EISENHOWER MEMORIAL

SECTION 106 CONSULTATION DECEMBER 9, 2014: COMMENT RESPONSES
MARCH 2, 2015

OVERVIEW

PLAN-DIAGRAM

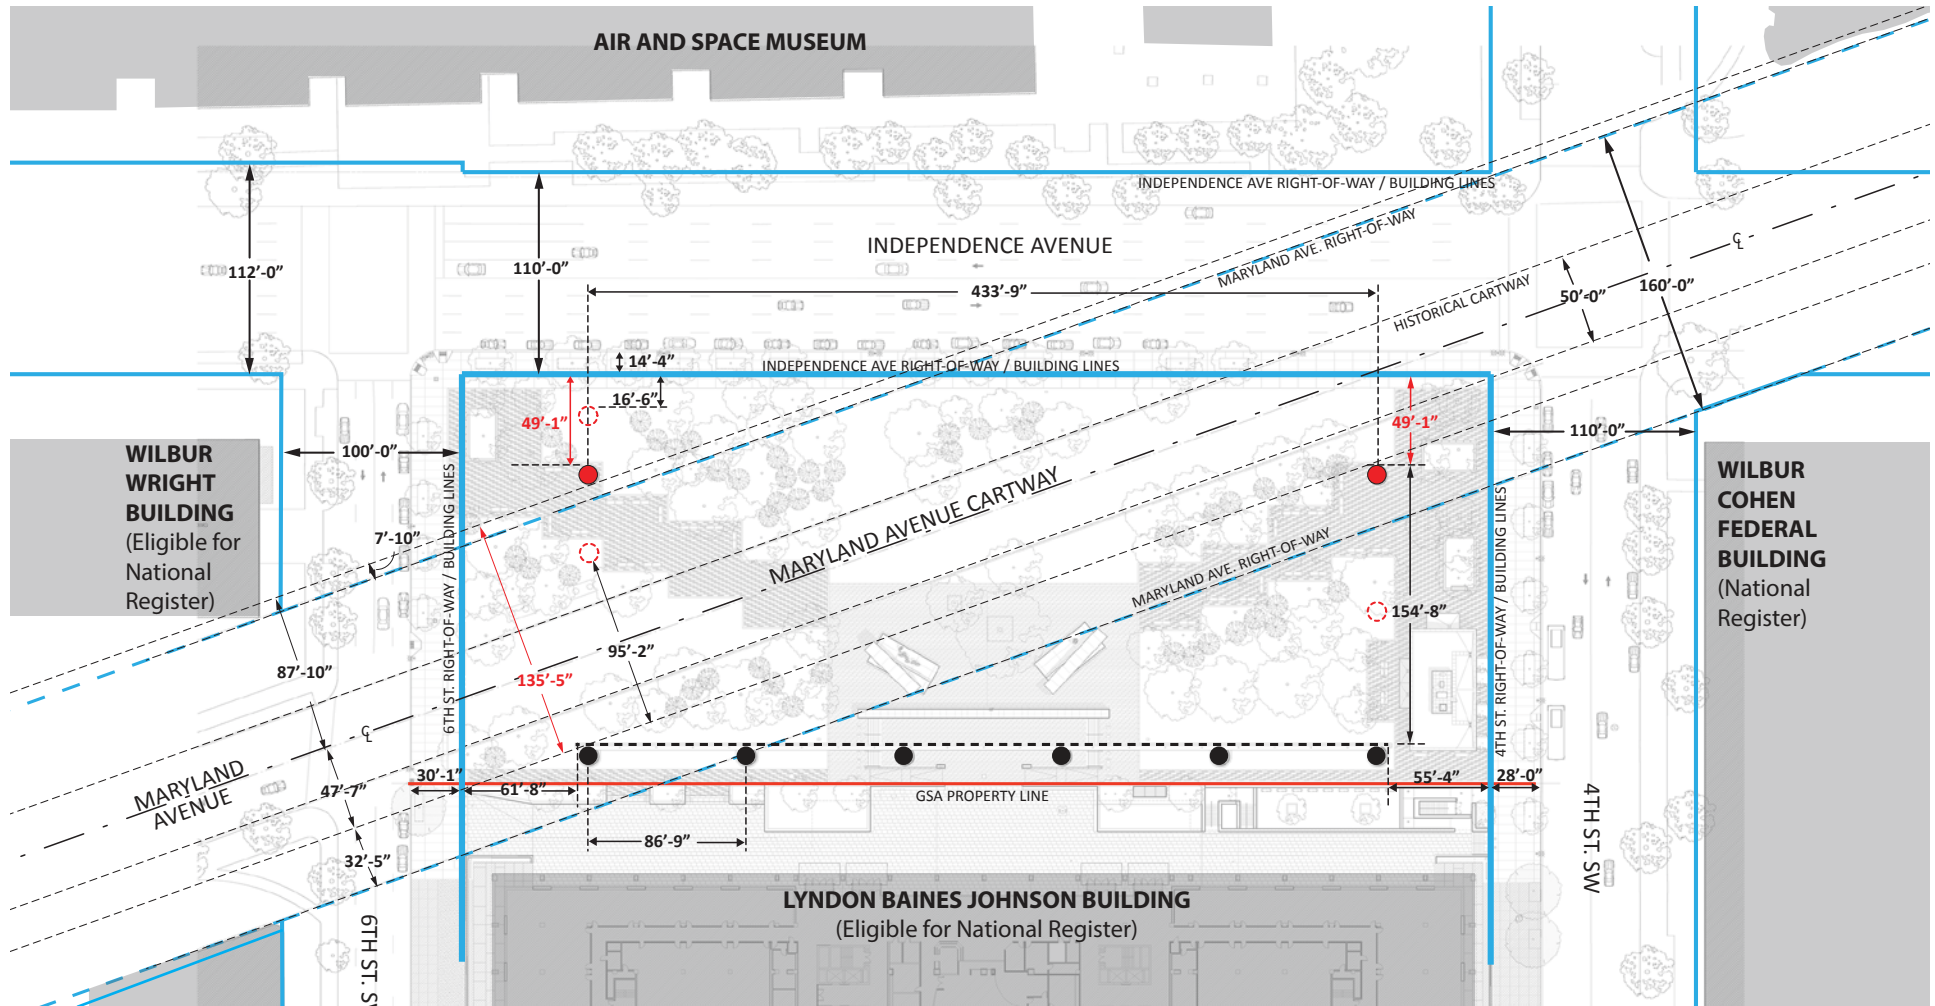
- With the widening of the view corridor, has the level of effect on the corridor and the L'Enfant Plan been minimized?
- With the removal of the side tapestries, has the level of effect on adjacent historic resources increased?
- Should there be paving along Maryland Avenue?
- Should there be sidewalks and benches along Maryland Avenue?

Response: Since 2012 it was considered that, as artwork, the columns do not intrude into the 160 foot wide ROW as would a building and the tapestry does not “violate” the 160 foot setback. In addition, the widened view corridor provides a more horizontal framing of the US Capitol. The Maryland Avenue corridor has been strengthened with enhanced tree planting and wider granite curbs to delineate the groomed lawn of the Avenue. These modifications mitigate the level of effect on Maryland Avenue and the L'Enfant Plan, particularly with respect to the current parking and modified pavement on Maryland Avenue, as developed in 1930.

The removal of the side tapestries allows the Wilbur Wright and Wilbur Cohen buildings to serve as frames defining the memorial site. This minimizes the visual effects on these adjacent historic buildings.

The majority of visitors are expected to enter the site from the corners on Independence Avenue. There is no destination route from the WMATA station at 7th Street. Because relatively few pedestrians are expected to traverse through the site as passersby, the turf design should accommodate pedestrian traffic levels. As a result, the design idea for the memorial is to provide two diagonal paths of small “outdoor rooms” and benches to slow pedestrian traffic as they approach the memorial core and allow for contemplative spaces.

The concept for Maryland Avenue is to provide a green experience from which to view the U.S. Capitol across the L'Enfant Plan axis. This new/restored tree-lined and groomed-lawn right of way space will provide an enhanced, less discordant experience for the public; in essence, the redesigned right of way mitigates the adverse effect. Introducing paving along Maryland Avenue, as well as sidewalks and benches, would conflict with the diagonal entry paths and reduce the amount of pervious surface on the site.

Overall, the current conditions of the site are a result of inefficient traffic movement due to the late introduction of Independence Avenue, which was a product of the McMillan Plan as it intersects with the L'Enfant Plan. Because of the widened view corridor, the reduced number of columns and tapestries, and the increased number of street trees, adverse effects on Maryland Avenue, the L'Enfant Plan, and adjacent historic buildings would be **minimized**.

NCPC PRELIMINARY APPROVAL PLAN (SHOWN IN COLOR) OVER DECEMBER 2011 PLAN (SHOWN IN RED)

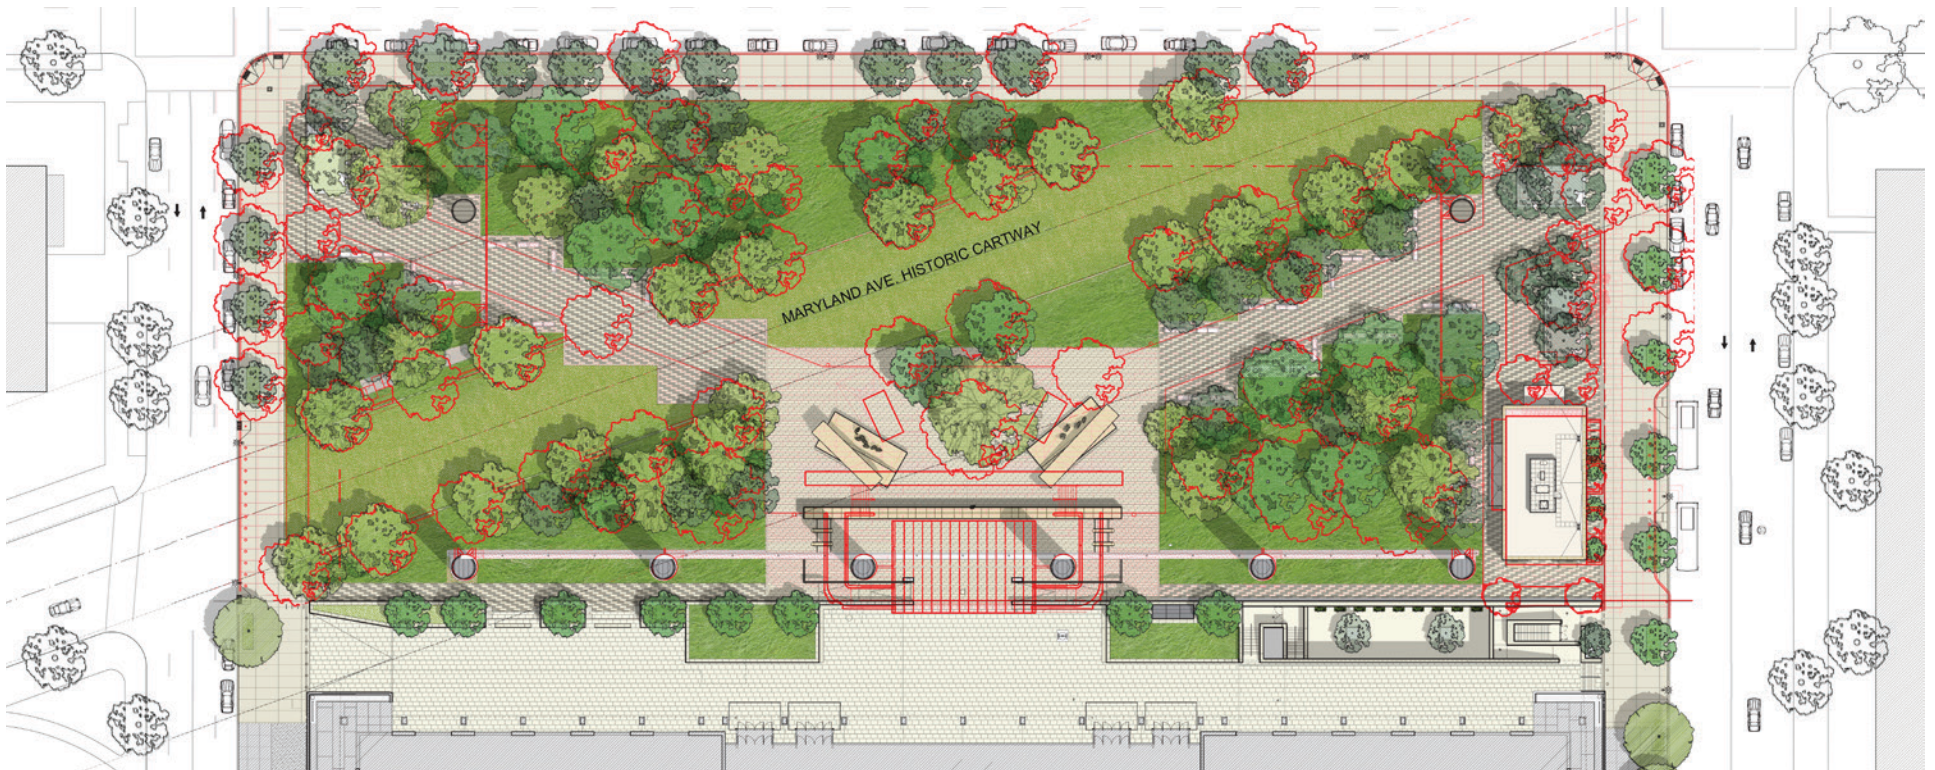
- Have the modifications to the central core elements changed the determination of effect?

Response: The design refinements to the central core artwork are subtle details that provide definition but **do not intensify a previously considered effect**.

SHADE CANOPY TREES COMPARISON

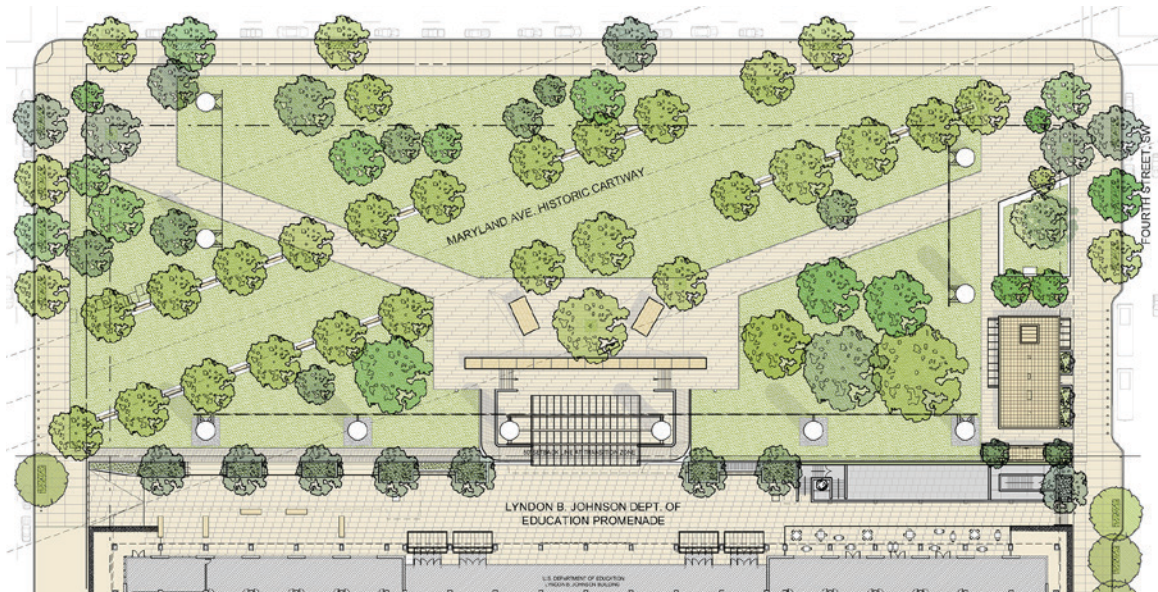
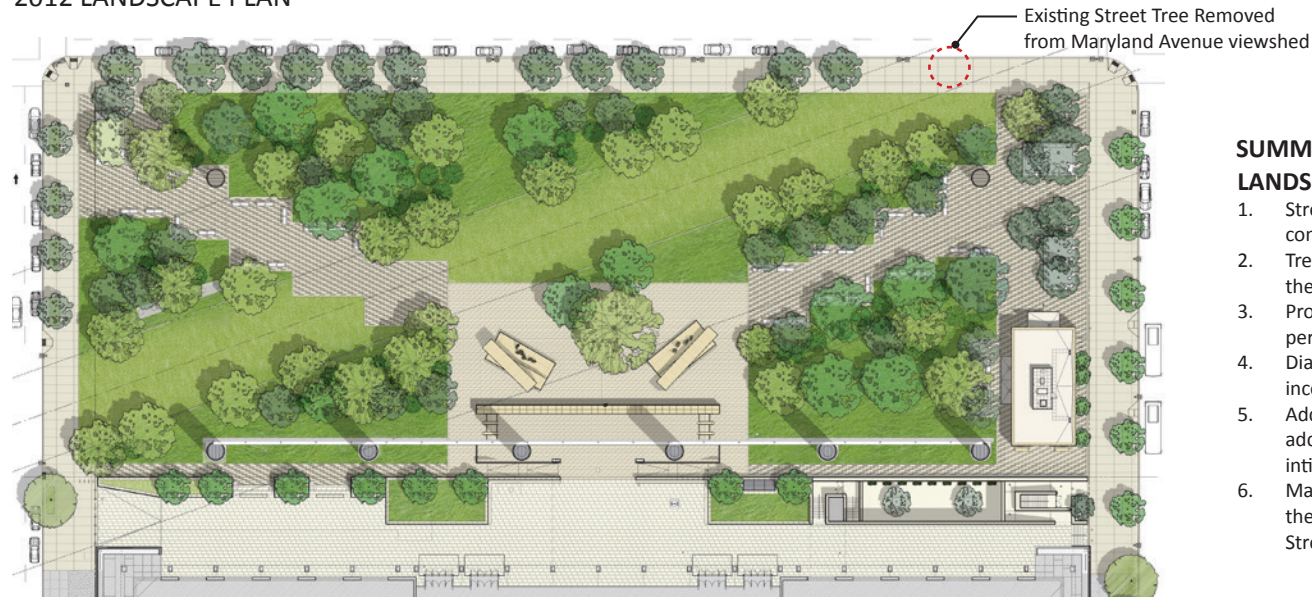
- With the additional trees, has the memorial's overall level of adverse effect decreased?
- Should the trees around the perimeter of the site be consistent or adhere to guidelines for street trees?
- Has the number of trees along Maryland Avenue changed?

Response: The enhancements to the landscape plan, including planting more shade and decorative trees, will make the site feel more like a park, which is consistent with the design principles. As a result, the level of effect certainly will not increase.

The District of Columbia, which has jurisdiction over roadway spaces in Washington, maintains strict requirements for the species and configuration of street trees along 4th Street, 6th Street, and Independence Avenue. The Memorial landscape plan complies with the applicable street tree regulations for those corridors.

The number of trees along Maryland Avenue has been slightly revised; a limited number of trees have been removed or reconfigured to accommodate the modified entry paths and afford more direct views of the Memorial from the perimeter of the site through the more densely planted park. The refinements allow for easier physical and visual access into the site and continue to **minimize** the level of effect.

INFORMATION CENTER FLOOR PLAN

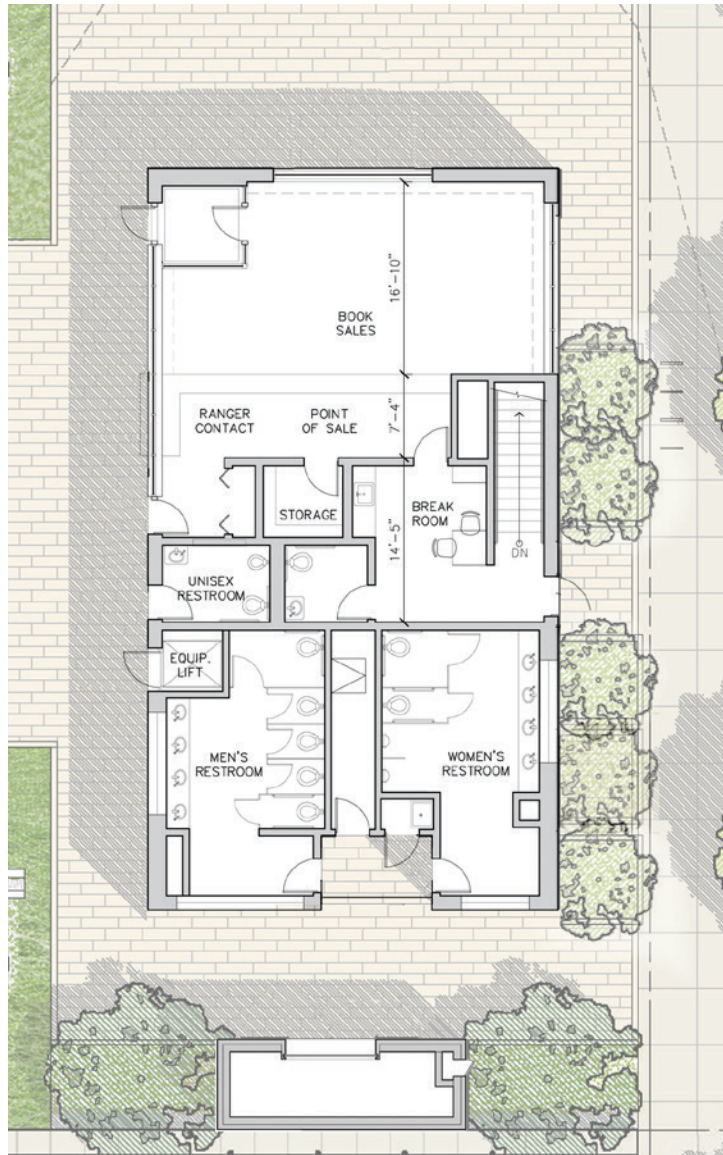
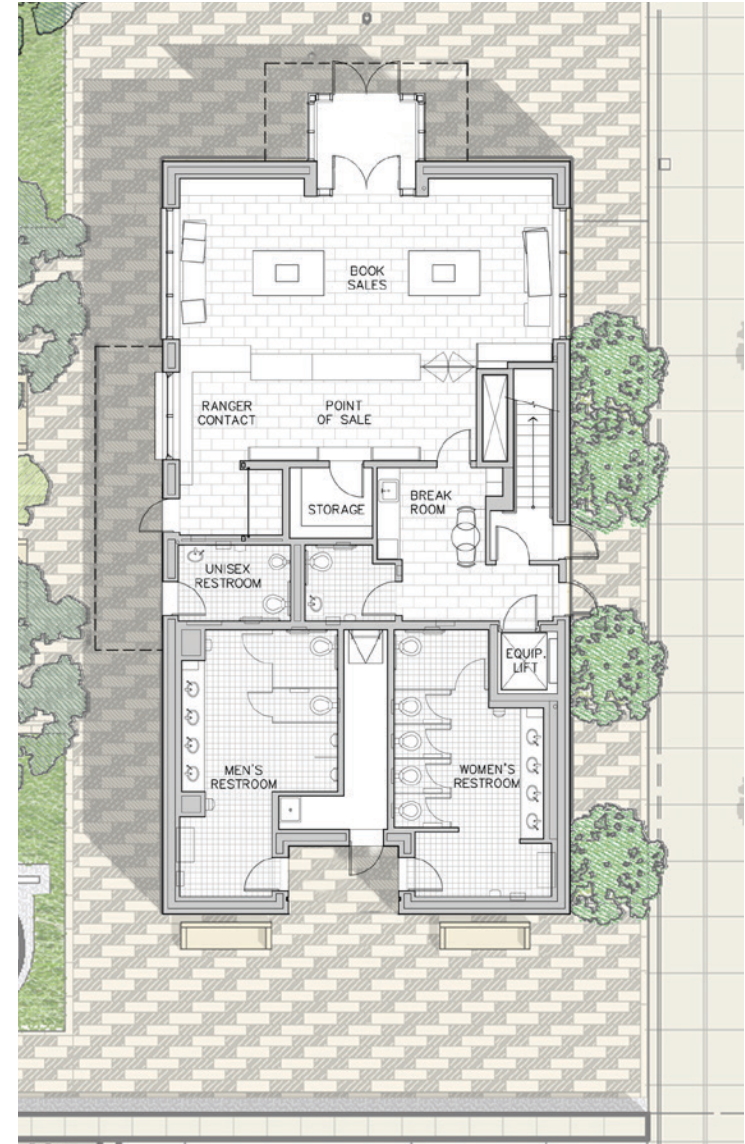
- With the removal of the shed, will the level of effect be intensified or minimized?

Response: The design advancements of the support building reduce the footprint of structures on the site and **minimize** its level of effect.

LIGHTING PLAN RENDERING OF PROMENADE AT NIGHT

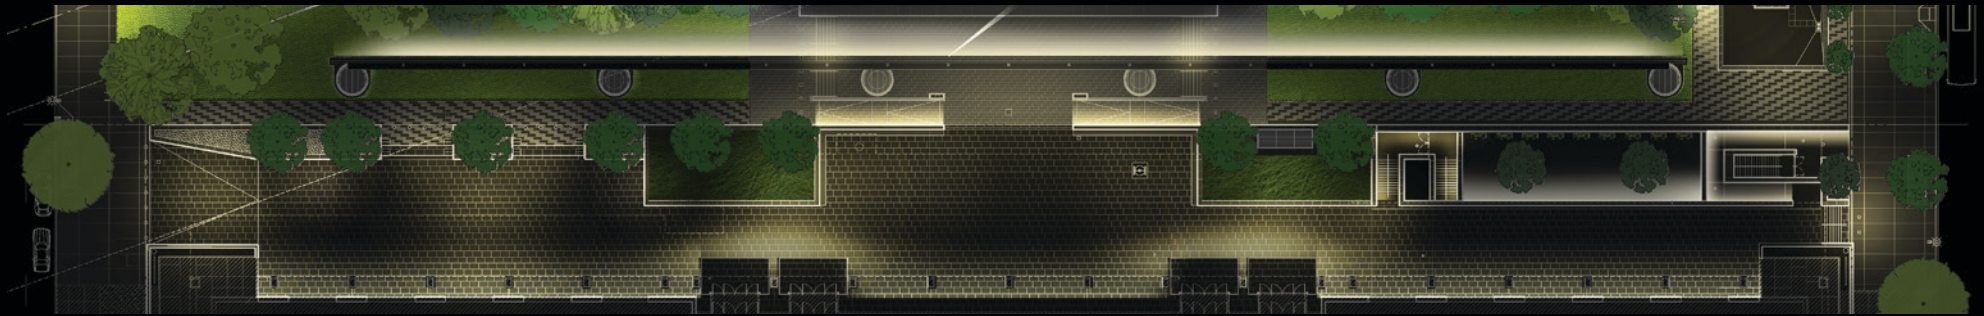
- Will the lighting of the LBJ promenade at night conflict with the tapestry's lighting?

The spaces created along the Promenade will have utilities and built-in audio visual hookups to facilitate setups for activities and events. The Promenade will be lit along the ground for pedestrian safety and will not affect the lighting levels in the Memorial site or on the tapestry. The LBJ building will not be lit internally at night as a result of the GSA/ Department of Education energy conservation program.

IN RESPONSE TO NCPC COMMENTS AND SECTION 106 CONSULTATION, THE TAPESTRY WAS REDUCED IN LENGTH BY 95' AND CENTERED ON THE LYNDON B. JOHNSON BUILDING.

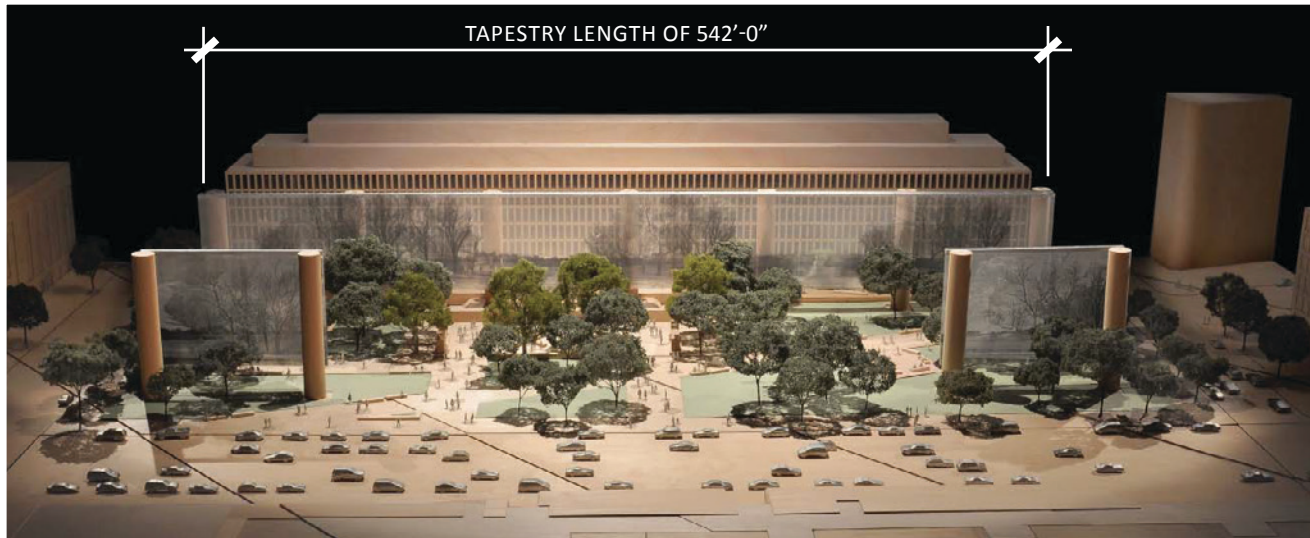
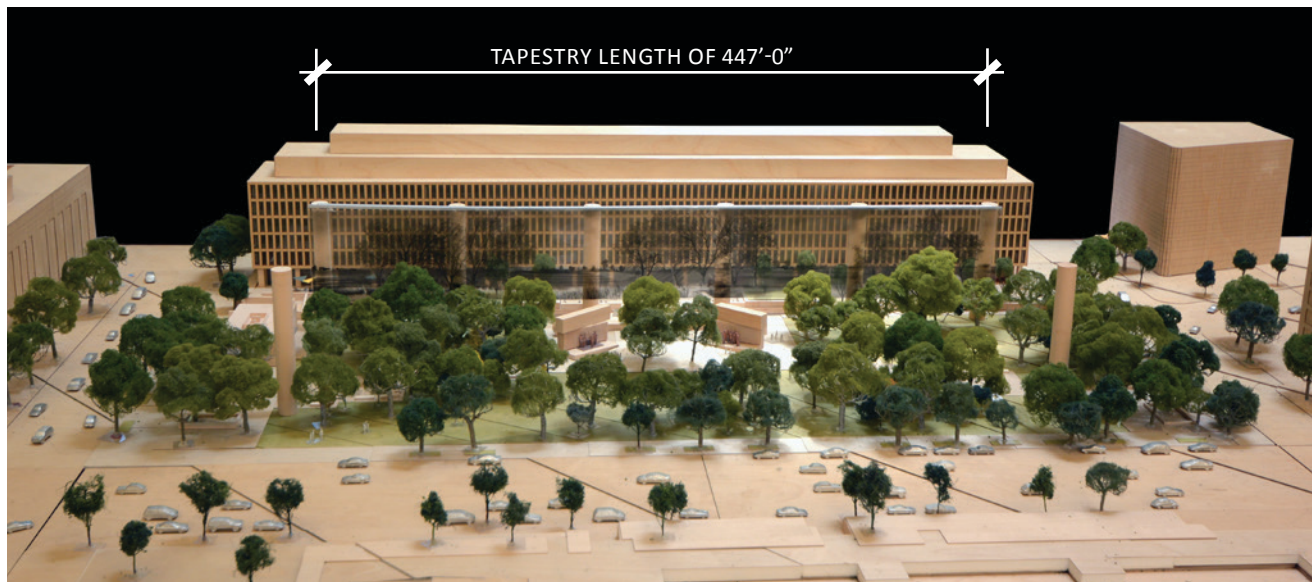
- Should the eastern-most and western-most tapestry bays be removed with the columns retained to mark the corners of the site?

Response: The memorial design team examined and considered a great number of versions of the south tapestry, including multiple iterations with smaller dimensions, removed bays, and reduced heights. After extensive exploration of the issue, the current size of the south tapestry was determined to be the optimal scale and width. Given the expanse of the 4-acre parcel, narrower tapestries along the south edge of the memorial site would appear as individual objects rather than as backdrop elements. Because the length and effect of the south tapestry was included in the 2012 MOA, retention of the currently designed length does not intensify a previously considered effect.

In addition, lighting of the tapestry is minimized from the ground level to remain a background feature relative to the illuminated Department of Education Building façade. As a result, the memorial lighting will not compete with the illumination level of the Capitol Dome, which is the dominant night-time feature.
